Model: ESI 1350

Product Bulletin # TDS-191

## Blower Motor Securement Upgrade

Figure 1: Blower Motor Assembly (P/N: 5021368) with improved housing for additional blower motor securement (P/N: 5021370)

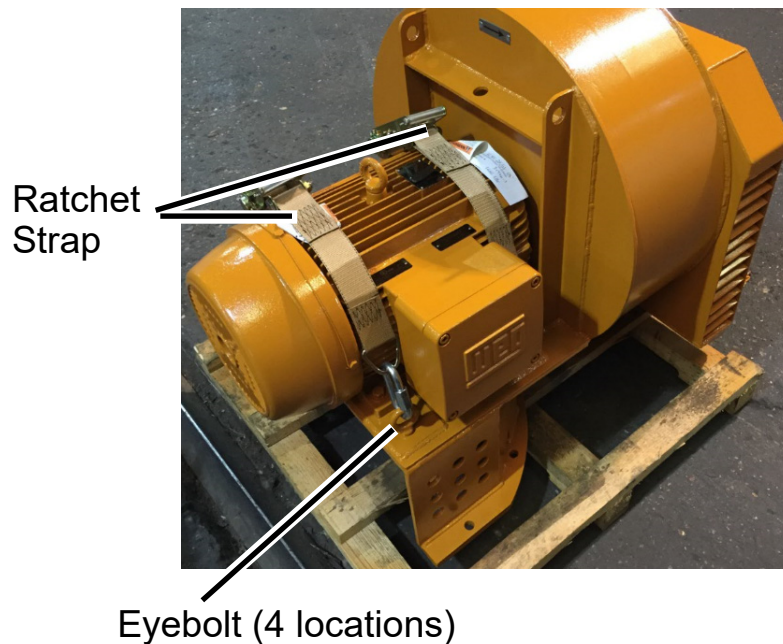
Excessive vibration may loosen the top drive blower on legacy TESCO 500-ESI-1350 top drives, and a lack of periodic inspection may lead to a potentially dangerous dropped-object situation.

An upgraded blower motor assembly (P/N : 5021368) is now available with an improved housing (P/N: 5021370), improving the mounting design for the blower motor. This improved housing has a controlled-machined surface, eliminates the rubber pad, and adds eyebolts and ratchet straps for additional securement. This improvement will be included in new top drive builds. Upgrades to existing top drives may only be performed by the original manufacturer (OEM). Contact Rigline 24/7™ Support to schedule an upgrade to the blower motor assembly.
